### Further Information Response

#### Planning Permit Application No. P4/2024

#### 321 Lower Heidelberg Road and 1 Maltravers Road, Ivanhoe East

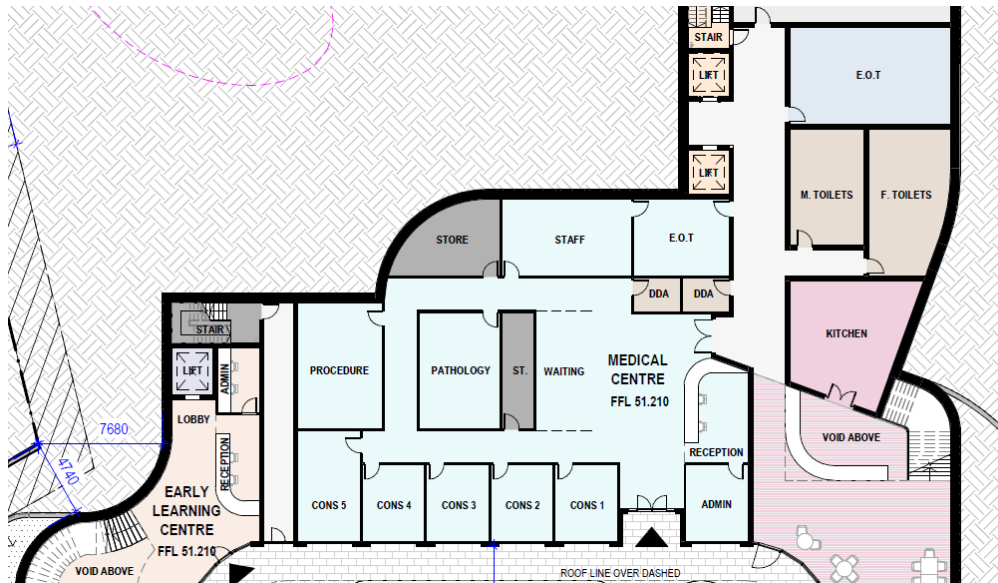
***"The ground level access to the medical centre and childcare centre are located behind the existing church building, obscured by the overhanging outdoor play area, do not directly face the public area and do not appear to include signage to identify the entry points. In particular, this is the only access point to the medical centre and the obscured entrance may result in difficulties in locating it and a potential place of entrapment."***

***The narrow hallway to the ground floor lift area (adjacent to the childcare/medical centres) also creates a potential area of entrapment."***

***The floor plan does not indicate that the medical centre has access to toilets other than one DDA accessible space."***

We have carried out a significant internal redesign of the lower ground floor plan in order to address these concerns. A summary of the key changes is noted below, which should be read in conjunction with the updated plans:

- Medical entry relocated further east to improve its sense of presence and legibility within the lower ground forecourt, as well as providing clearly delineated entries for all separate building functions and address identified safety concerns;

- An additional internal entry to the medical centre has been added, to facilitate visitors who arrive via the primary entrance lobby on Lower Heidelberg Road, and to allow access to additional toilet facilities on lower ground floor;

- Additional wayfinding and building signage has been added to facilitate improved visibility into the lower ground forecourt;
- Vertical circulation has been revisited, with an additional lift added adjacent to the primary lobby space accessed from Lower Heidelberg Road, to accommodate a better flow of visitors to all levels and functions of the development;

- The western stairwell has been redesigned to eliminate safety concerns around concealment / entrapment in this area;
- Glazing to the café area has been increased in both height and width to provide greater sightlines from Lower Heidelberg Road towards the centre of the forecourt;

- The eastern café courtyard has been deleted and replaced with increased planter beds, to allow for expanded landscaping opportunities to Lower Heidelberg Road and eliminate safety concerns around concealment / entrapment in this area.

## URBAN DESIGN COMMENT 05

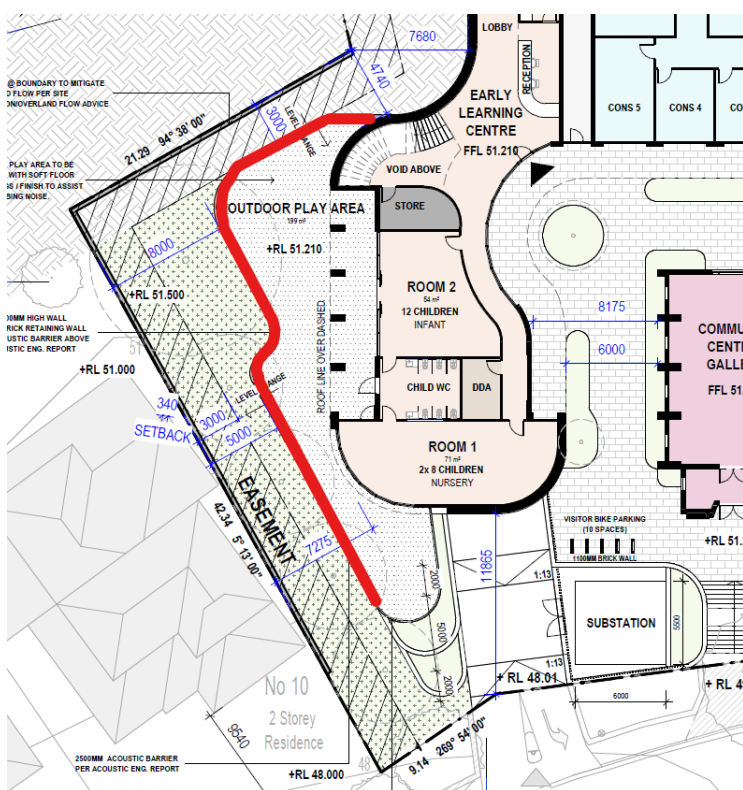
*“Remove the brightly-coloured glazing associated with the Early Learning Centre*

- We recommend replacing the proposed brightly-coloured glazing with a far more muted material that is more sympathetic to the character of King Street, such as timber or brickwork. Doing so will further assist the proposal to integrate into its local context and character.”*

For clarity, the below extract highlights the extent of coloured glazing in plan. The remaining curved section of the play area (i.e. the section presenting to the street) consists of a low-level brick wall, in keeping with the general architecture of the building and the surrounding context.
